RTCA Special Committee 186, Working Group 5

ADS-B UAT MOPS (DO-282), Revision A

Consolidated Set of Comments to be considered for DO-282A

Consolidated Comments to the FRAC Draft of the proposed revision to the UAT MOPS, RTCA DO-282A
RTCA Paper No. 032-04/SC186-218

Figure 1 – Sensitivity Variation with Frequency, All 1's Interrogation, Transponder MS-1

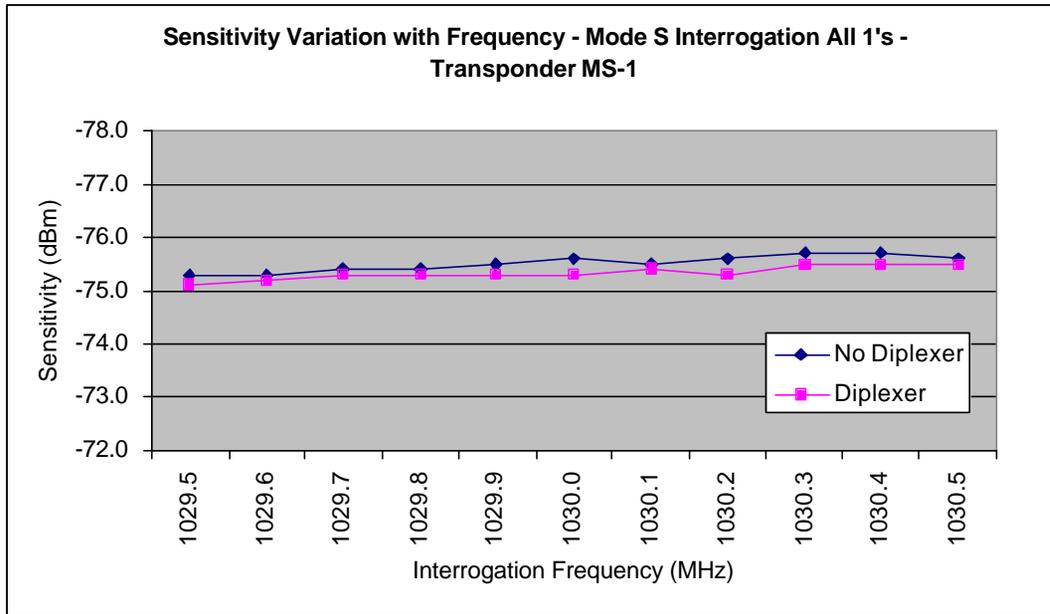
Comment		Section	Page	Comment	Suggested Resolution
#	Author				
	Tom Pagano #3	E.3.1.1	E-9	Since the passive Diplexer integrates UAT equipment with the SSR transponder of the aircraft, it was necessary to coordinate the use of a Diplexer with the Surveillance and Collision Resolution Systems Panel (SCRSP) of the International Civil Aviation Organization (ICAO). SCRSP produces and maintains international standards for the Mode S and SSR systems. The results of the extensive tests that were conducted to verify proper operation of the SSR transponder with a passive Diplexer were made available to SCRSP to evaluate the performance of the SSR transponder through the Diplexer. An additional set of tests were recommended by SCRSP to investigate the performance of a Mode S transponder with the use of a Diplexer and its ability to properly decode Mode S interrogations with numerous Differential Phase Shift Keying (DPSK) phase shifts.	The results of the DPSK tests at the FAA WJH Technical Center should be added into the overall Diplexer test results that are being presented in the revised Appendix E of RTCA DO-282A. We propose adding the text and Figure that is attached to this comment form onto the end of the revised FRAC Draft of section E.3.1.1.

Since the passive Diplexer integrates UAT equipment with the SSR transponder of the aircraft, it was necessary to coordinate the use of a Diplexer with the Surveillance and Collision Resolution Systems Panel (SCRSP) of the International Civil Aviation Organization (ICAO). SCRSP produces and maintains international standards for the Mode S and SSR systems. The results of the extensive tests that were conducted to verify proper operation of the SSR transponder with a passive Diplexer were made available to SCRSP to evaluate the performance of the SSR transponder through the Diplexer. An additional set of tests were recommended by SCRSP to investigate the performance of a Mode S transponder with the use of a Diplexer and its ability to properly decode Mode S interrogations with numerous Differential Phase Shift Keying (DPSK) phase shifts. These tests would verify that the bandwidth of the Diplexer does not cause distortion of the interrogation signal that would degrade the ability of the Mode S transponder receiver to properly decode these interrogations. In order to evaluate the Diplexer impact on DPSK, the transponder receiver sensitivity was tested as interrogation frequency was varied. Three Mode S type transponders were tested both with and without the Diplexer installed in order to make a direct comparison of the Diplexers effect. The transponders tested were from three different manufacturers. The installation of the Diplexer affects the Voltage Standing Wave Ratio (VSWR) of the antenna ports so a slotted line and stub tuner were used to monitor and control VSWR. The stub tuner was used to set the VSWR to the same minimum value obtainable with and without the Diplexer. This was done to minimize the VSWR influence on the sensitivity measurements.

Figure 1 shows a plot of the Sensitivity Variation with Frequency measurements for one of the transponders tested. The interrogation consisted of a legal uplink format defined by the first five bits of the interrogation. All other data bits equal to binary ‘1’ except the Address Parity (AP) field, which was properly coded to elicit a response from the transponder. The all binary 1’s format was used to maximize the number of phase shifts in the uplink interrogation. This was the primary interrogation format used to test all three transponders. The data shows a consistent average reduction in sensitivity of about 0.2 dBm, the loss through the Diplexer, which does not vary significantly with frequency. Additional tests were conducted with all variable data bits equal to binary ‘0’ to minimize the number of phase shifts with nearly identical results.

All three tested Mode S transponders yielded similar results. The conclusion from running these tests is that other than the expected reduction in the transponder receiver sensitivity from the loss across the Diplexer, the Mode S sensitivity is not affected as a function of frequency within the operating bandwidth of the transponders. The Diplexer bandwidth characteristics for the SSR transponder channel adequately handles 1030 MHz Mode S interrogation signals with excessive DPSK phase variations.
